Tech Referral  
Aurora Water  
Jenny Wynn  
jwynn@auroragov.org

# SITE PLAN WITH ADJUSTMENTS

# 2252 TOWER ROAD

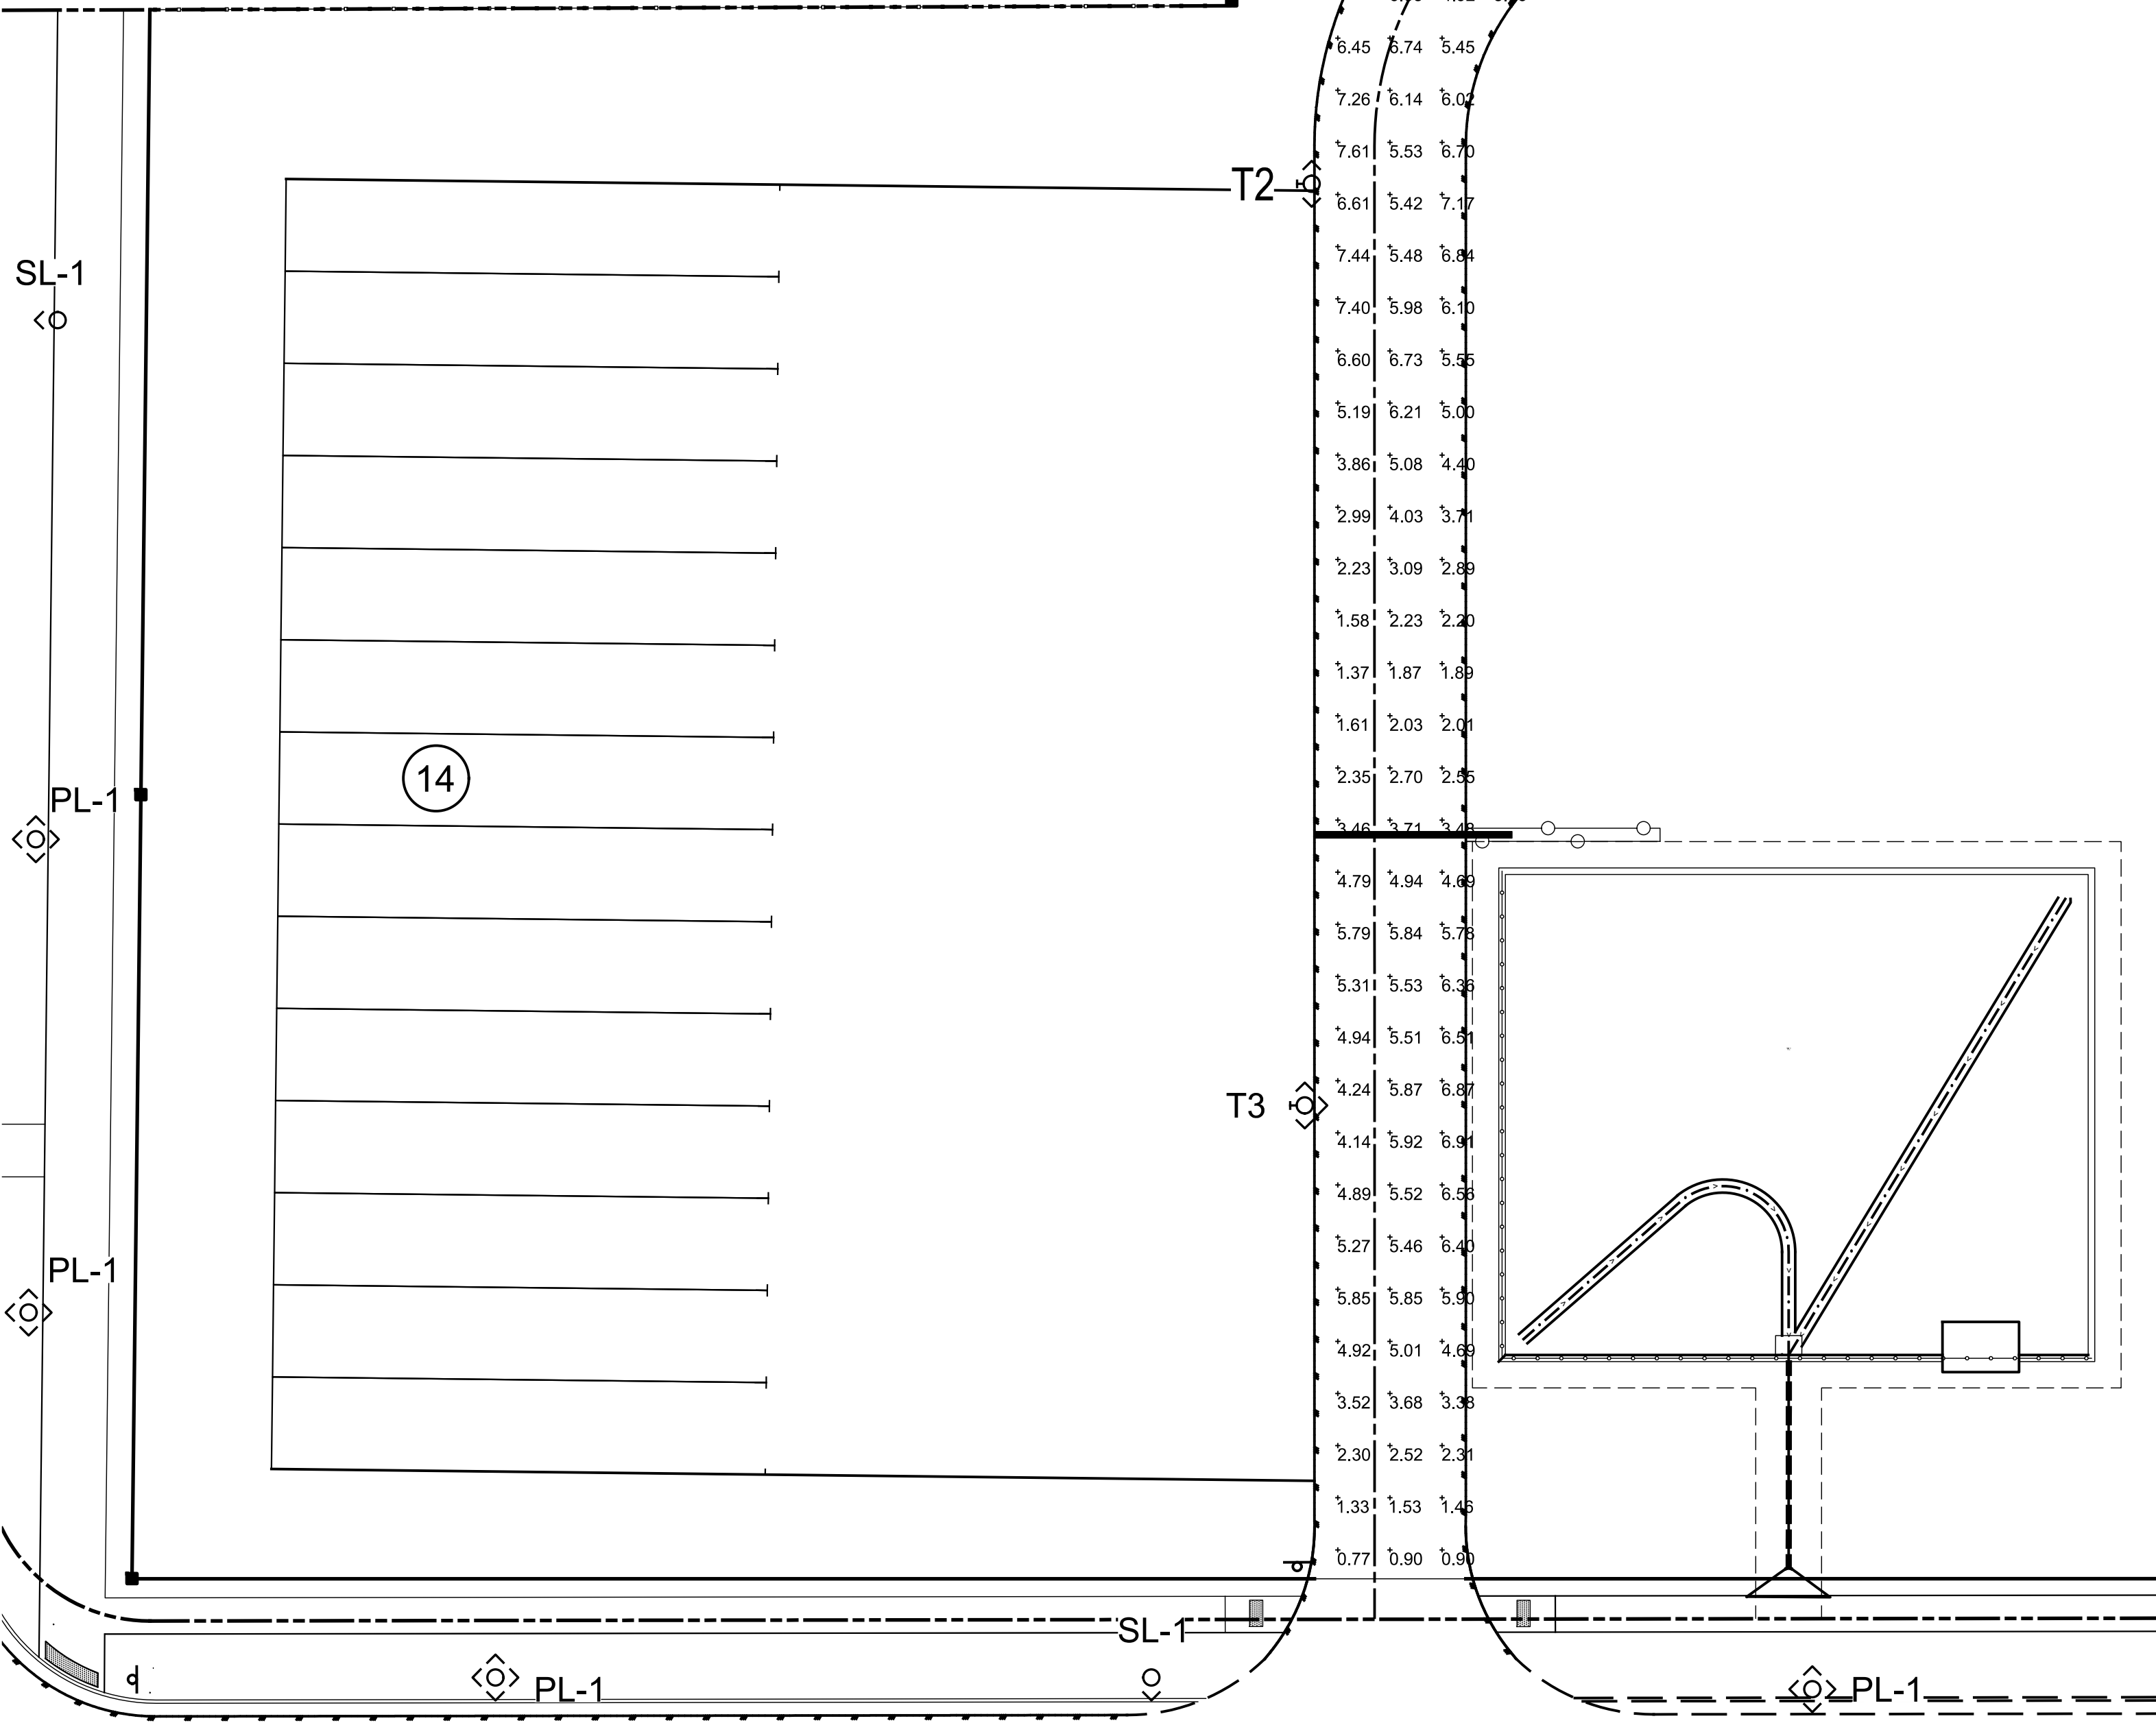
The photometric plan needs to show light spillover onto the adjacent properties to the north and far west sides of the site as well.
